APPLICATION NO.	FILING DATE	FIRST NAMED INVENTOR	ATTORNEY DOCKET NO.	CONFIRMATION NO.
10/821,383	04/09/2004	Christopher H. Porter	203/505 MB-104	1604
27224	7590	03/06/2009		
ARTHUR FREILICH FREILICH, HORNBAKER & ROSEN 20555 DEVONSHIRE ST. #372 CHATSWORTH, CA 91311			EXAMINER KOHARSKI, CHRISTOPHER	
			ART UNIT 3763	PAPER NUMBER
			MAIL DATE 03/06/2009	DELIVERY MODE PAPER

Office Action Summary

DETAILED ACTION

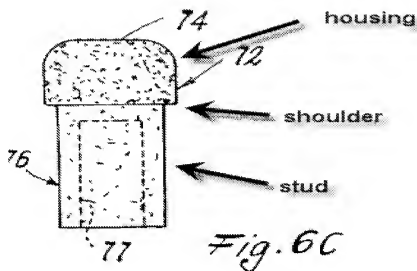
Regarding claims 3-8 and 18-23, Beoni discloses a medical device comprising (Figures 6C): a housing body (74) having a longitudinal peripheral surface (near 72)

defining a substantially uniform lateral dimension capable of subcutaneous implantation by surgical tunneling; a stud (76) projecting longitudinally from said housing body (74) capable of percutaneous implantation having an inner end adjacent to said housing (72) body and an outer end spaced longitudinally therefrom to define a longitudinal peripheral surface; a shoulder surface (intersection of 72 and 76) on said housing body (72) extending laterally from said housing body longitudinal peripheral surface to said stud longitudinal peripheral surface; a longitudinally extending porous layer (entire surface of device shown in Figure 6C) carried by said stud longitudinal peripheral surface having a lateral dimension no greater than said housing body lateral dimension; a laterally extending porous layer carried by said shoulder surface having a lateral dimension no greater than said housing body lateral dimension; and wherein said longitudinally extending and said laterally extending porous layers orthogonally (intersection of 72, 76) abut one another and wherein each of said porous layers is characterized by a pore size within the range of 50 to 200 microns (col 3, ln 35-40) (Figures 5A-6C).

Beoni meets the claim limitations as described above except for the specific porosity and metallic materials.

The Examiner suggests further clarification of the porous layer location and size relative to the housing and stud.
